ADDENDUM #5

RFP Number: 23-016-3340	Title: Antioch Water Treatment Plant Phase 3A Expansion
	Date: June 8, 2023
Issuing Officer: Greg Bridges	Bid Initially Solicited: April 27, 2023
Email Address: gebridges@forsythco.com	Telephone: 770-888-8872

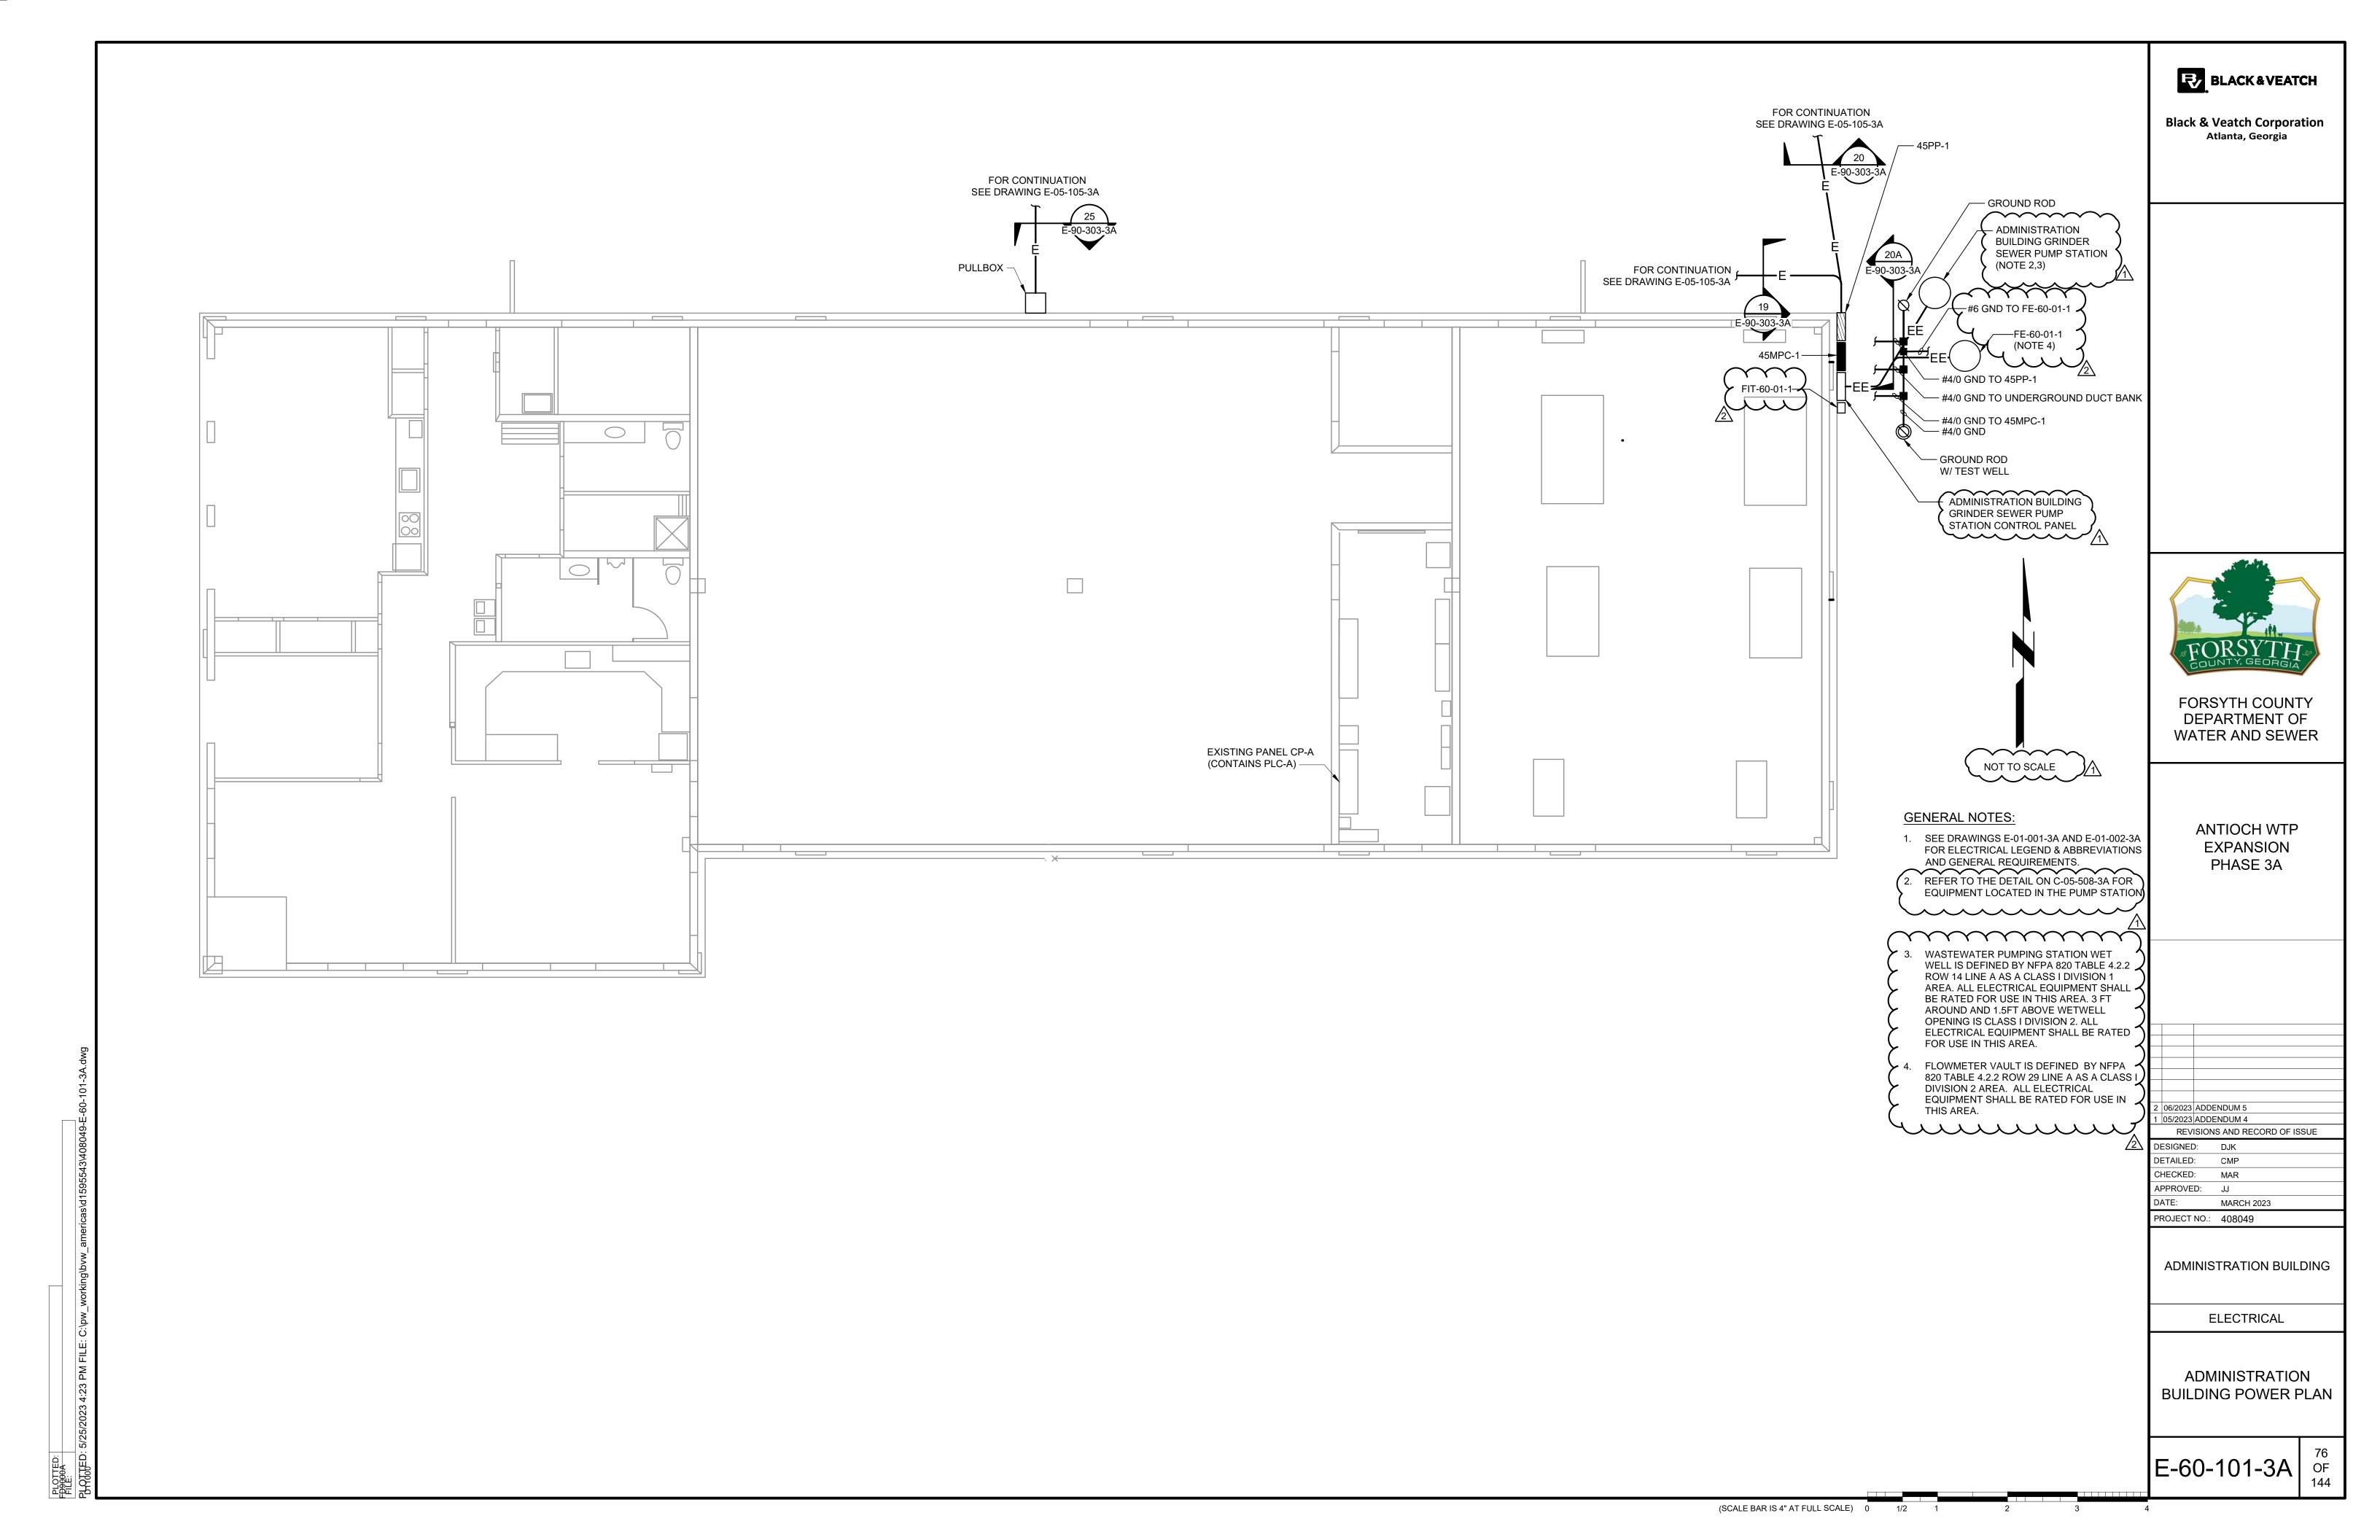
60.	General comment: Please consider removing the grated walkway at the	S-25-102-3A	The grated walkway can be removed if needed for installation of the cover

#	Question	Referenced Bid Section	Answers					
		Section						
	North end of the Filter Basin for		system but must be replaced with a					
	aluminum cover clearance.		walkway that can traverse the area.

E-90-616-3A OF 144

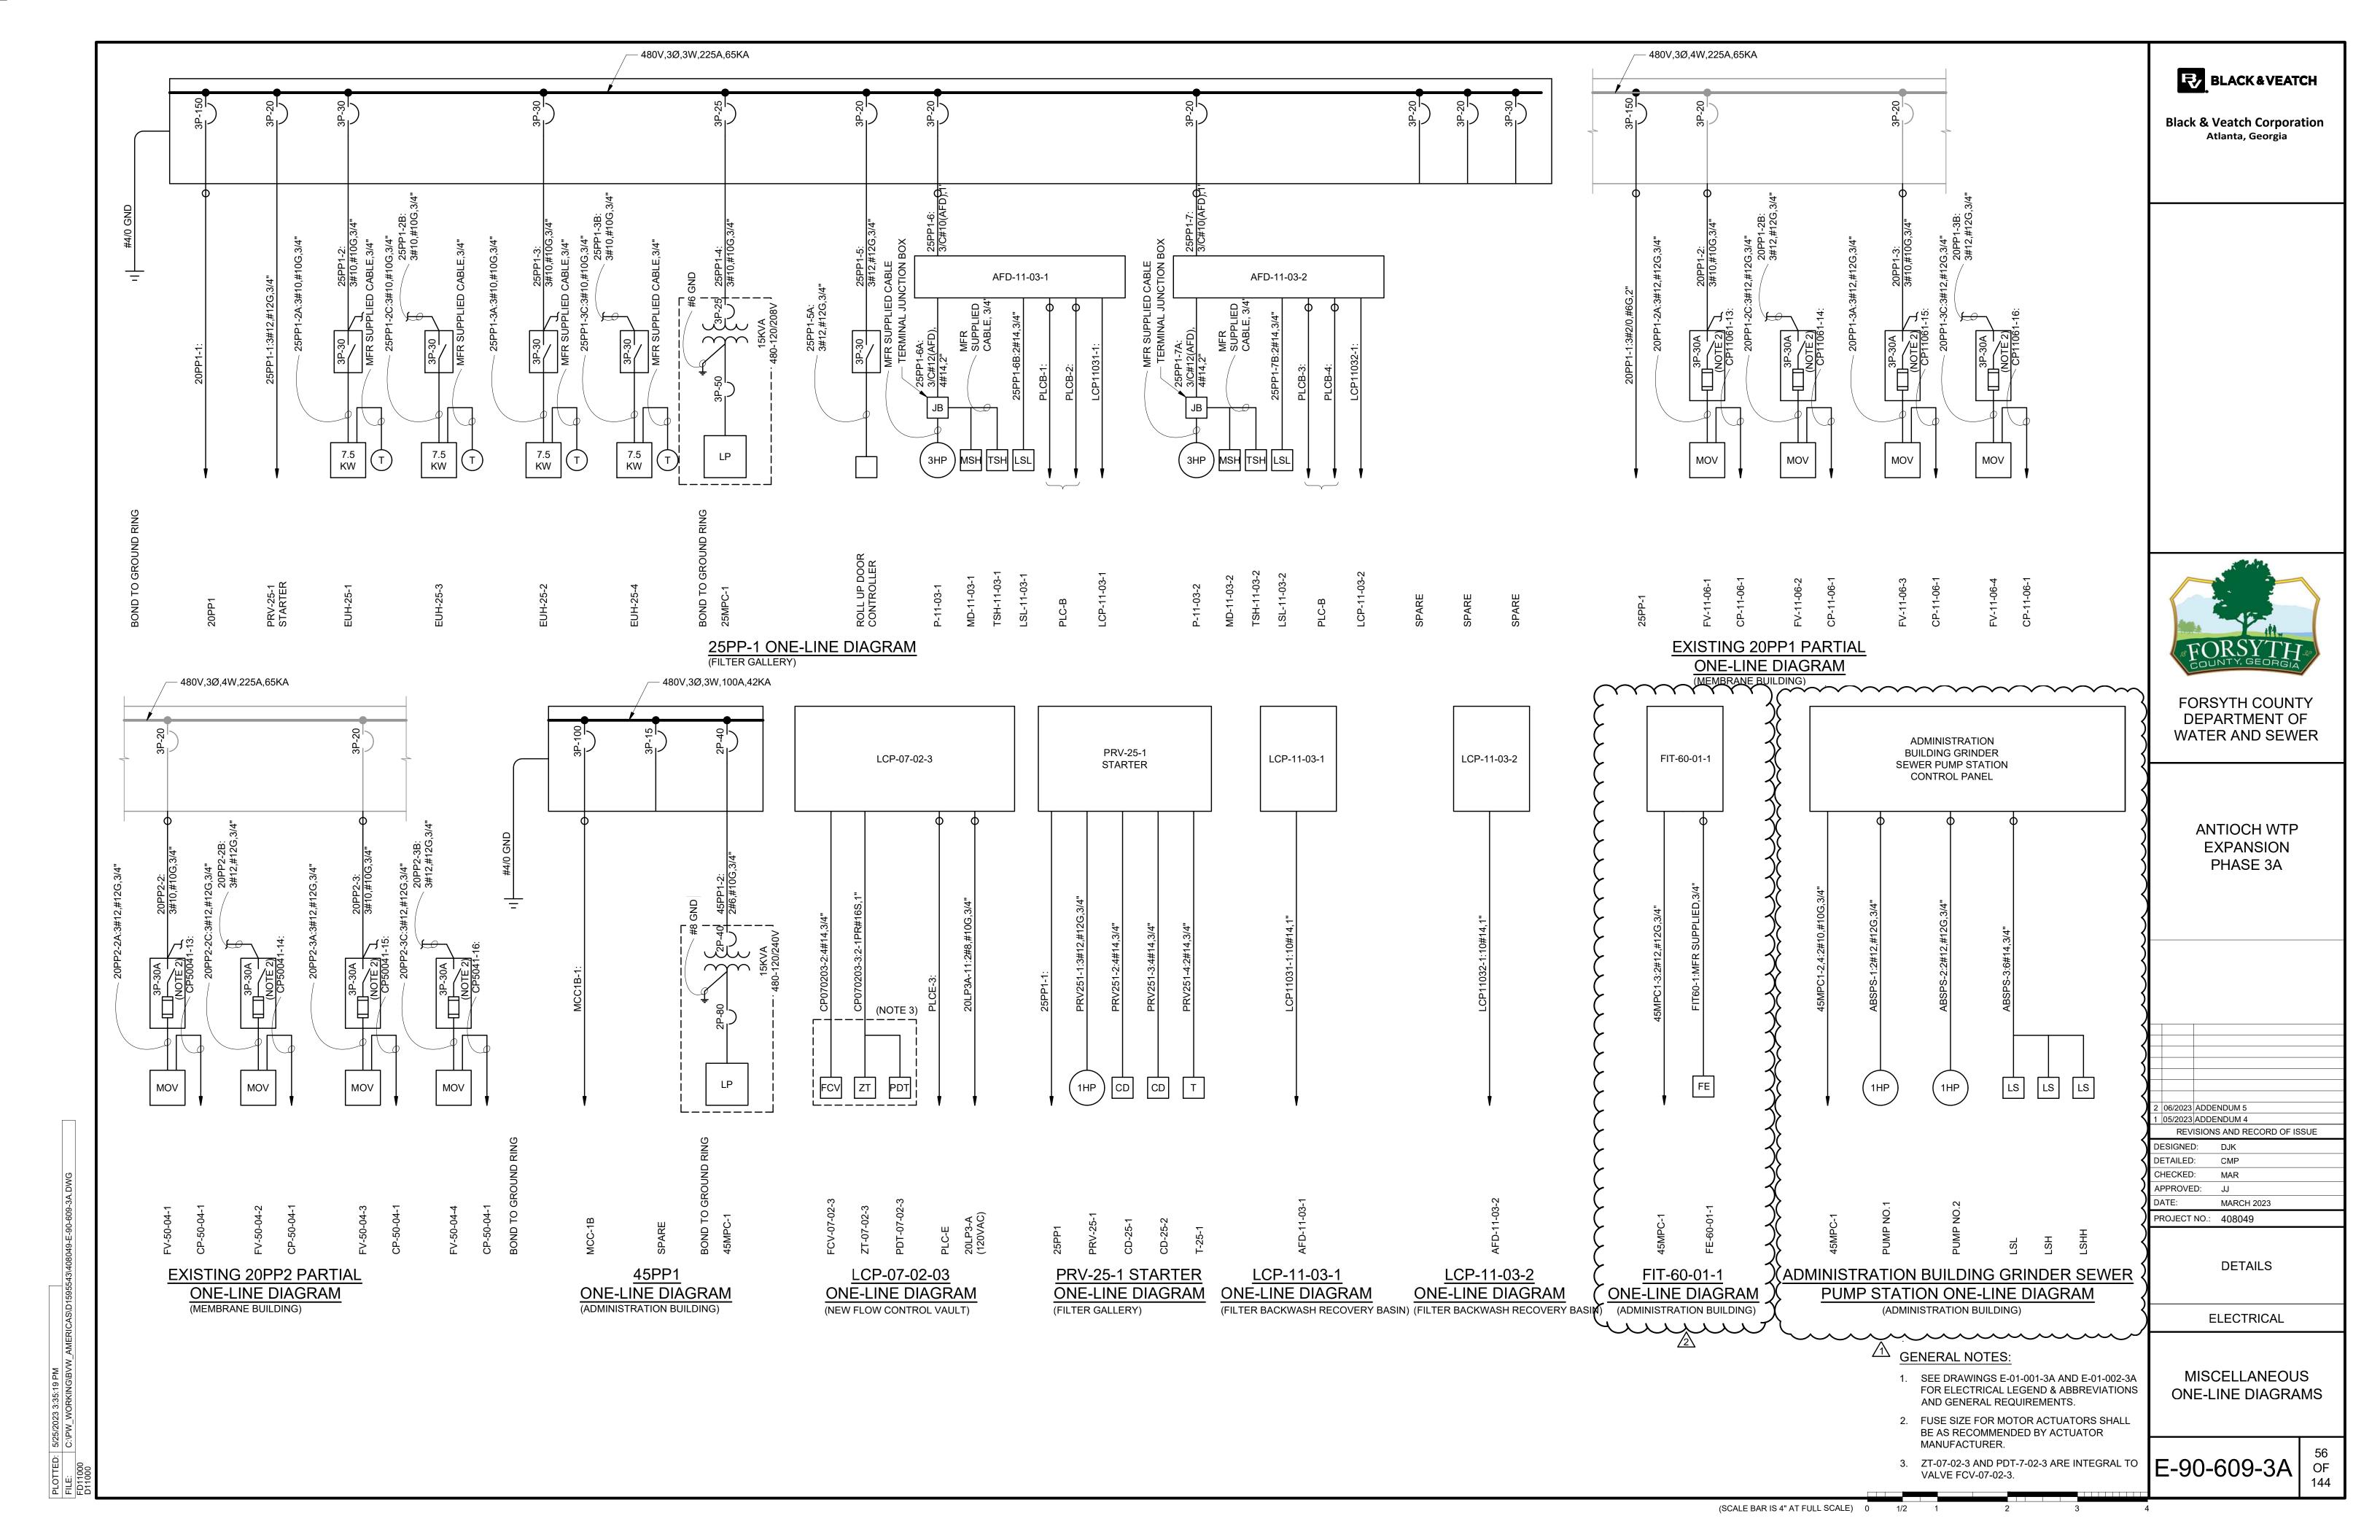
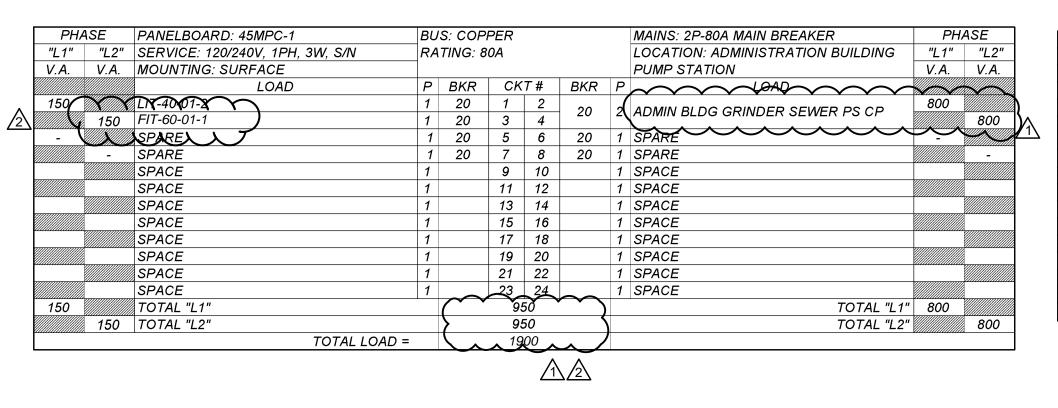
2 06/2023 ADDENDUM 5 05/2023 ADDENDUM 4 REVISIONS AND RECORD OF ISSUE

I-90-504-3A

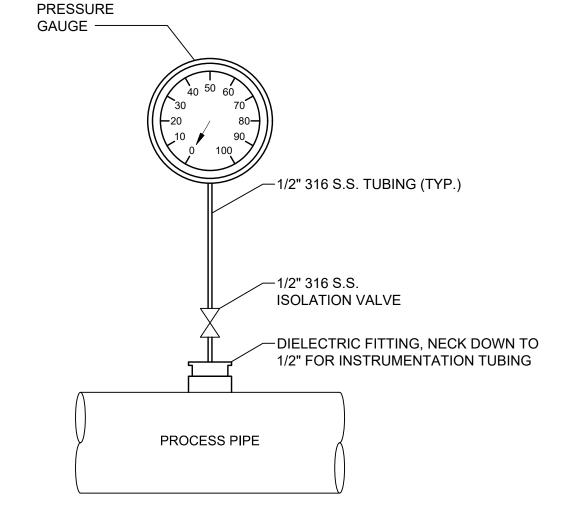
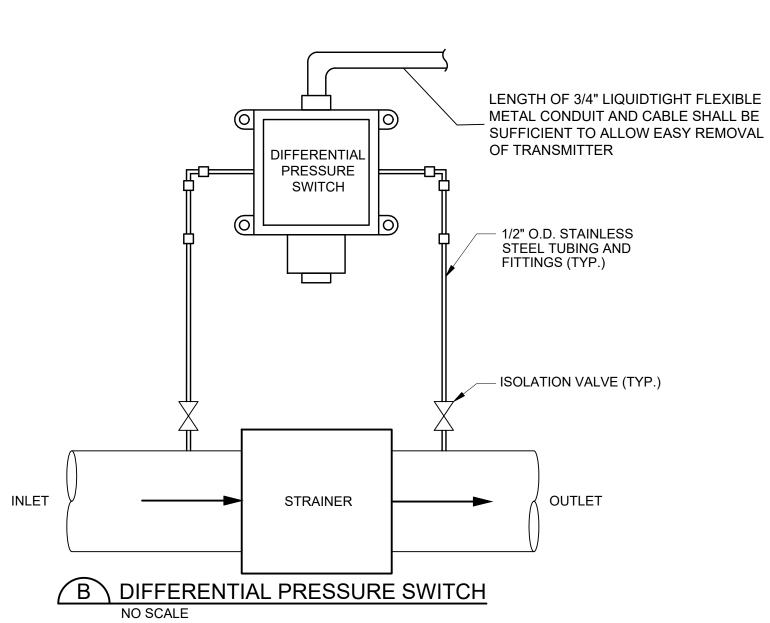
70.	Will a flowmeter be needed for the low pressure sewer pump station?	40 61 11A 40 71 00 C-05-116-3A C-05-507-3A E-60-101-3A E-90-303-3A E-90-609-3A E-90-616-3A I-90-504-3A	Provide a 3-inch magnetic flowmeter on the 3-inch low pressure sewer line, downstream of the low-pressure sewer pump station, per the new and edited specifications and edited drawings. Flow measurements shall be capable to 25 gpm. Install the flowmeter at an elevation in an upwardly sloping pipe section to ensure full pipe flow conditions at the meter. Work includes the addition of a doghouse manhole with project drawings attached. Also, notes and a detail have been added for pavement replacement.
